401 Water Quality Certification for the Atlantic Coast Pipeline

Rick Webb, Program Coordinator, Dominion Pipeline Monitoring Coalition (DPMC)

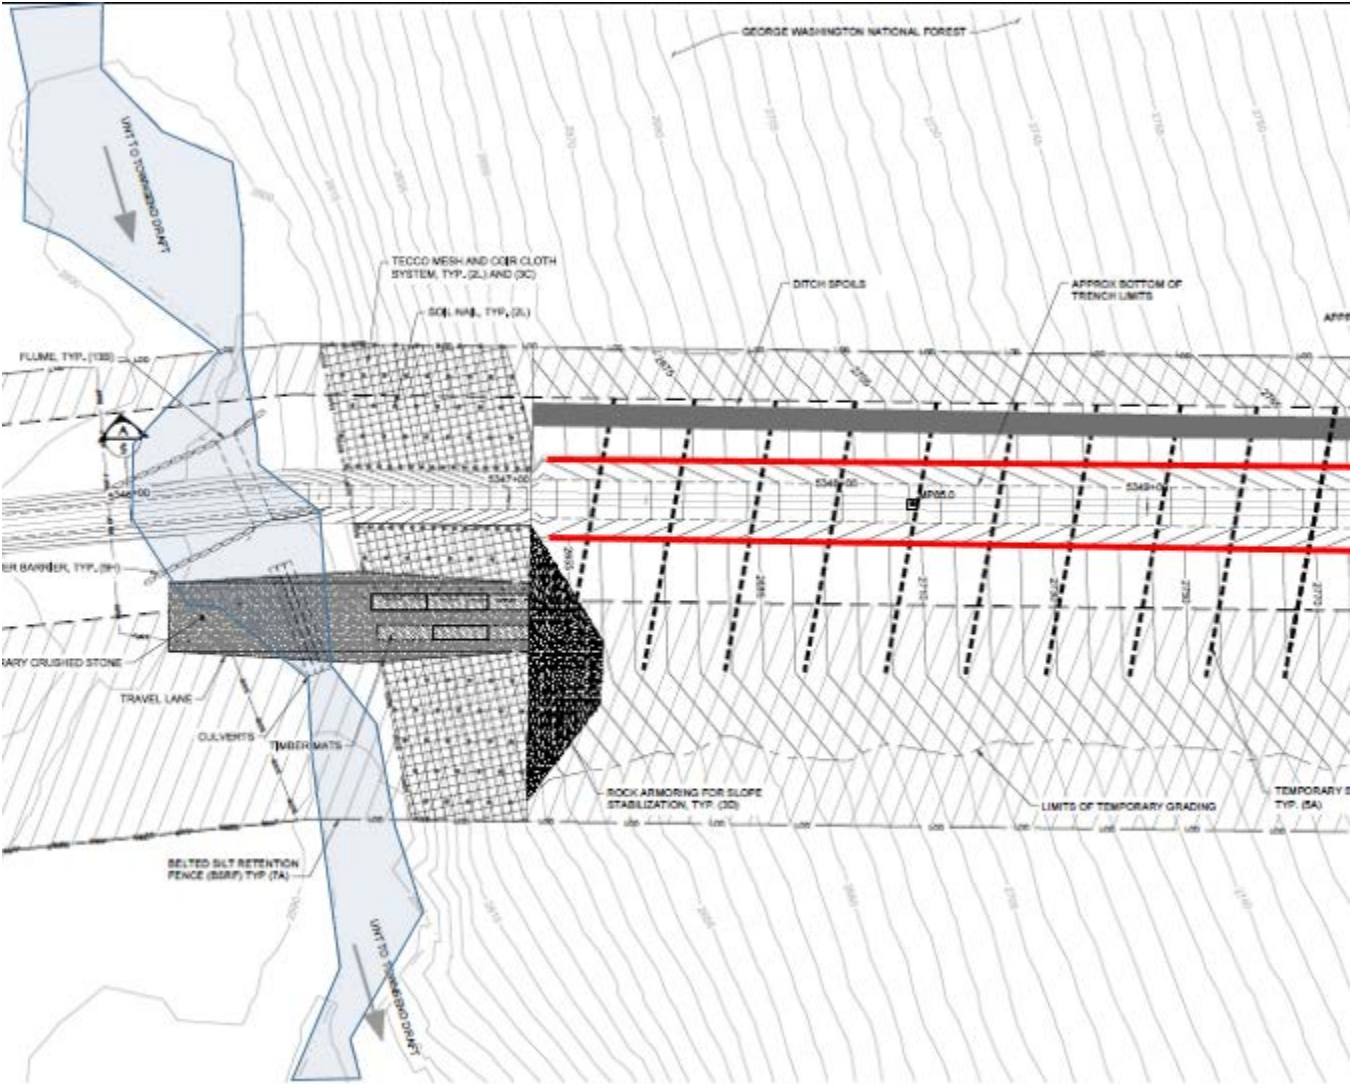
A 0.1 mile section of the ridge in the foreground is the only area in Virginia for which site-specific details for Dominion’s so-called “Best in Class” program have been provided. Final “Best in Class” details will not be submitted until after construction has begun.

The “Best in Class” program applies to all areas with slopes greater than 30% and lengths of 100-feet or more: at least one-third of the proposed route and access roads in the Virginia mountains.
